Re: Taxiway Improvements
Watertown Regional Airport
Watertown, South Dakota
AIP #3-46-0058-047/048-2025
Helms #A-9070

ADDENDUM NUMBER 1

The following modifications are made to the plans and specifications for the Taxiway Improvements Project, Watertown Regional Airport:

TAXIWAY C PLAN VIEW
STA:305+00 TO 310+00
TAXIWAY IMPROVEMENTS
WATERTOWN REGIONAL AIRPORT
WATERTOWN, SOUTH DAKOTA

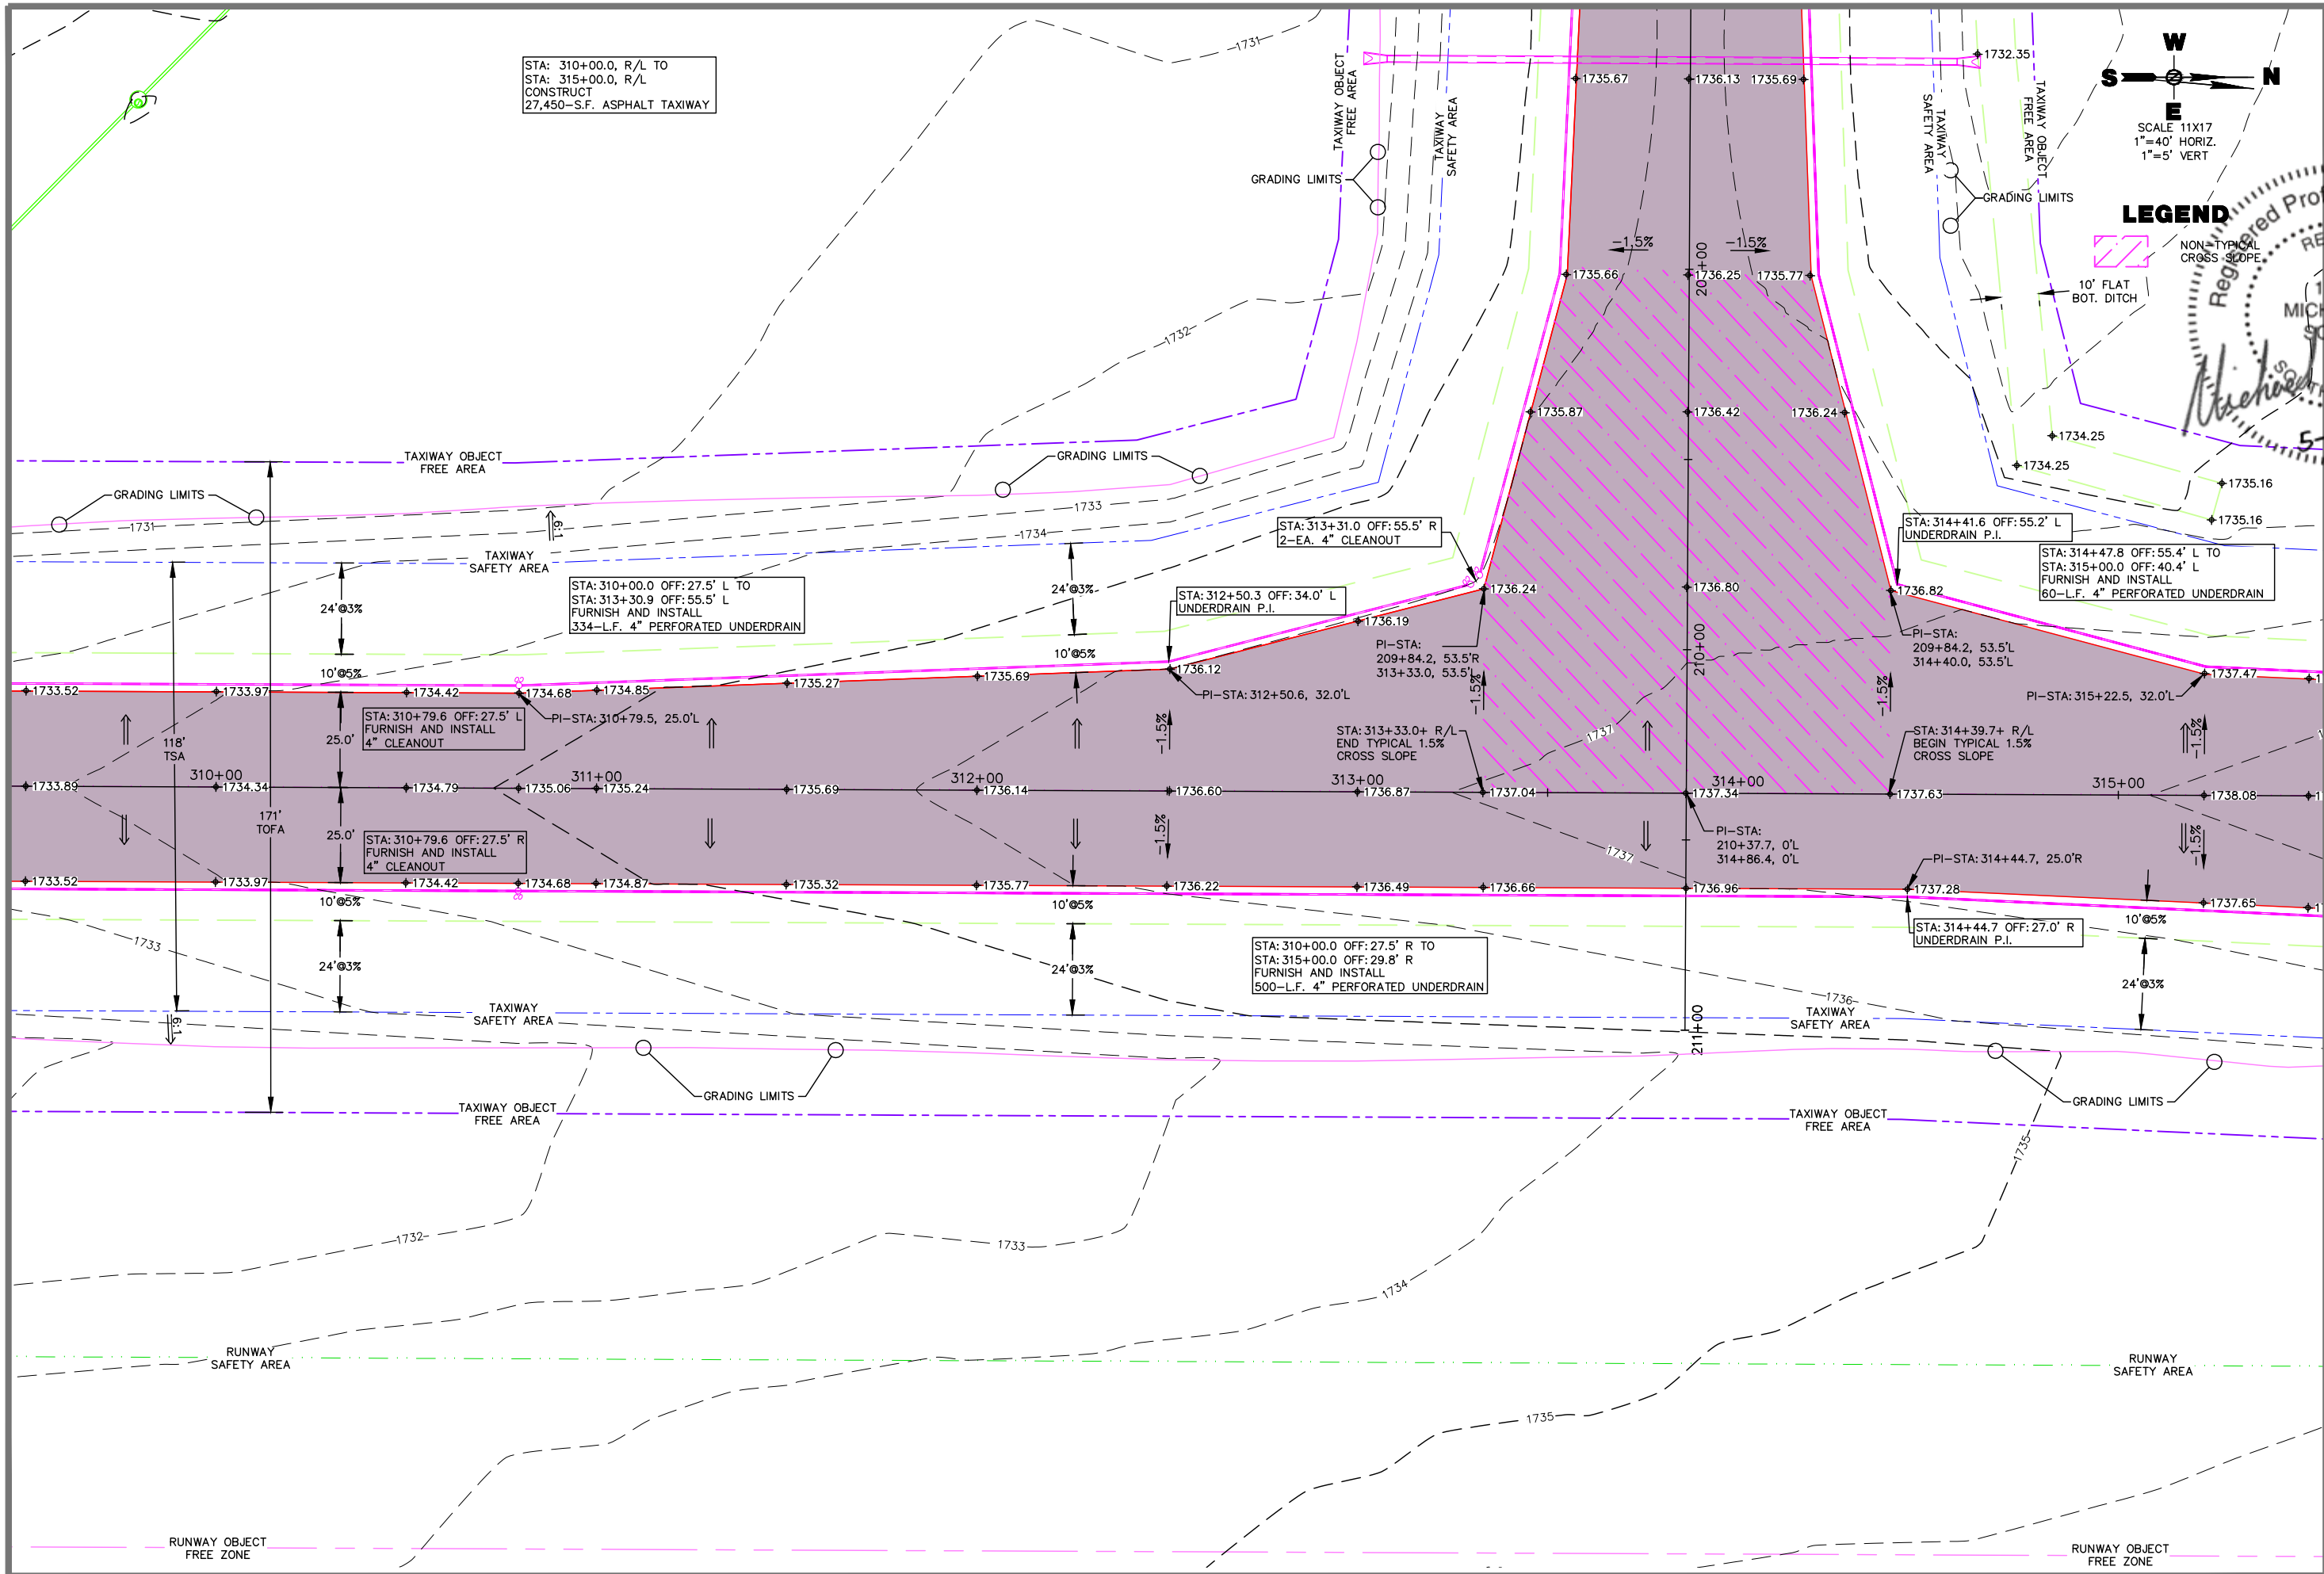
10. Taxiway C Plan View, Sheets 29, 31, 33, delete in their entirety and replaced with the attached Sheets.

Labeled the Runway Safety Area and Runway Obstacle Free Zone.

LIGHTING PLAN

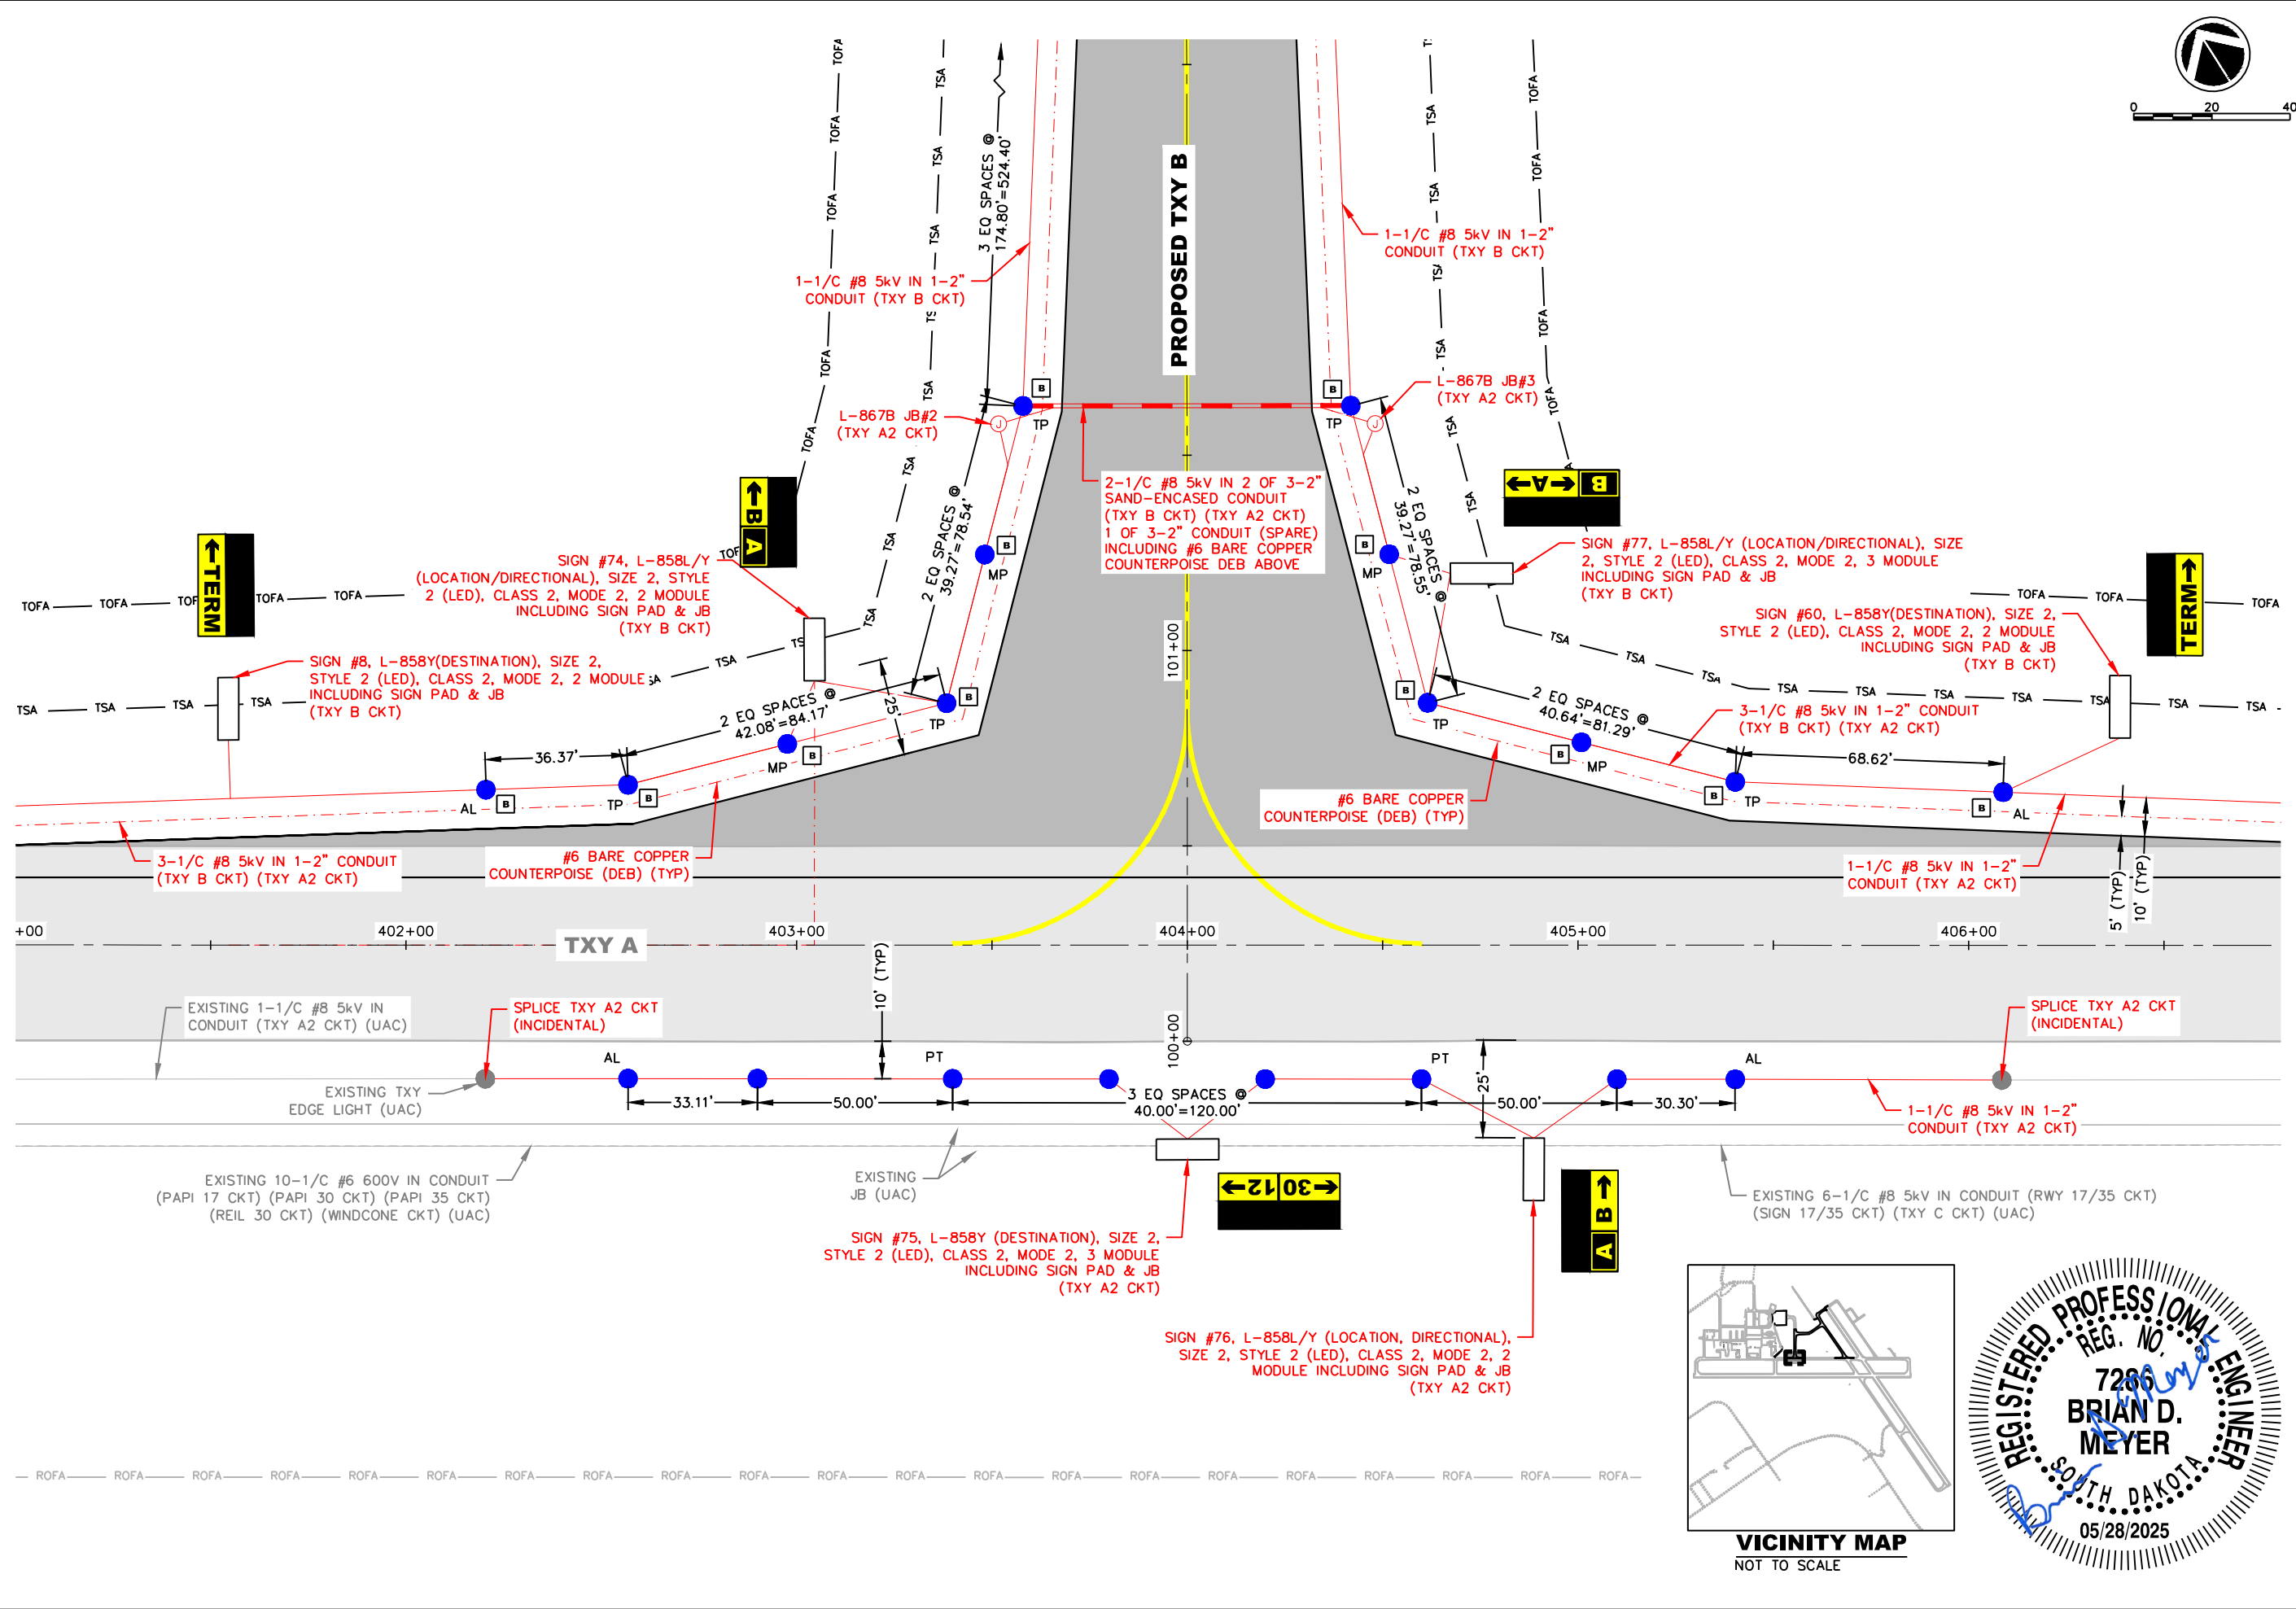
DAF | 2025-05-22 | ADD. NO. 1 - SIGN LEGEND UPDATES

Sheet
E13

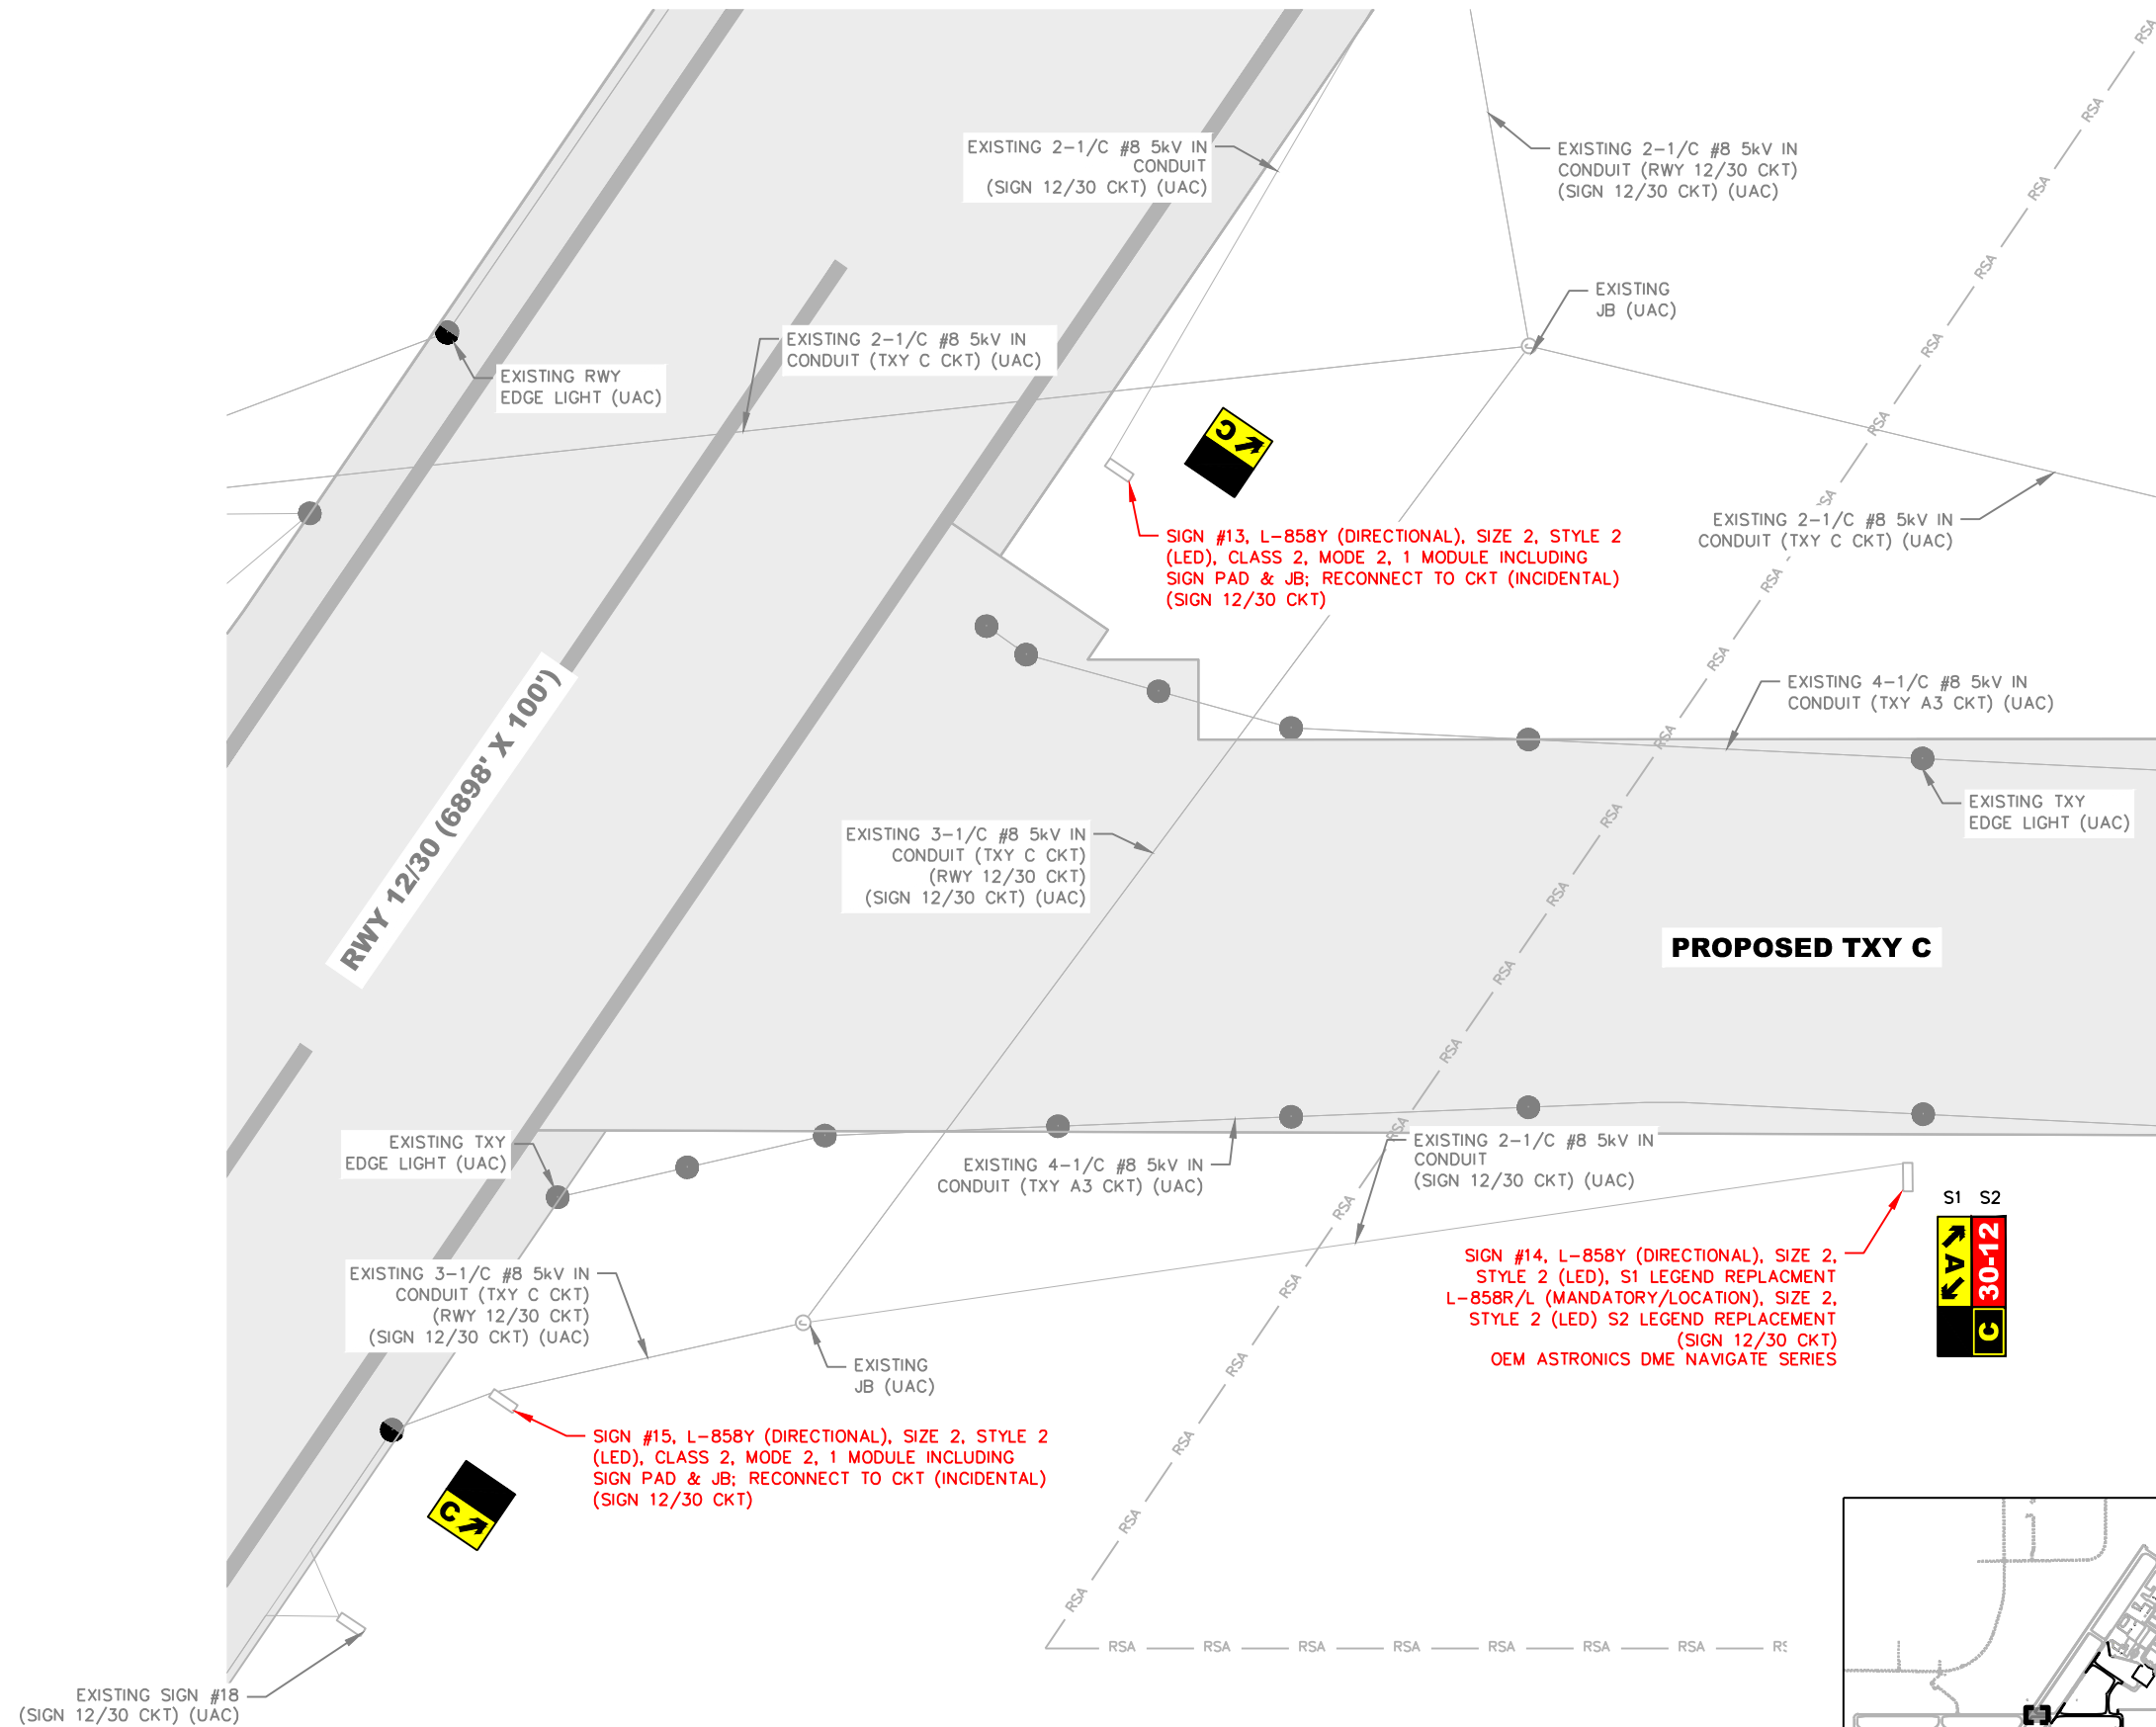
SIGN #14 - EXISTING S1
TO BE REPLACED

SIGN #14 - EXISTING S2
TO BE REPLACED
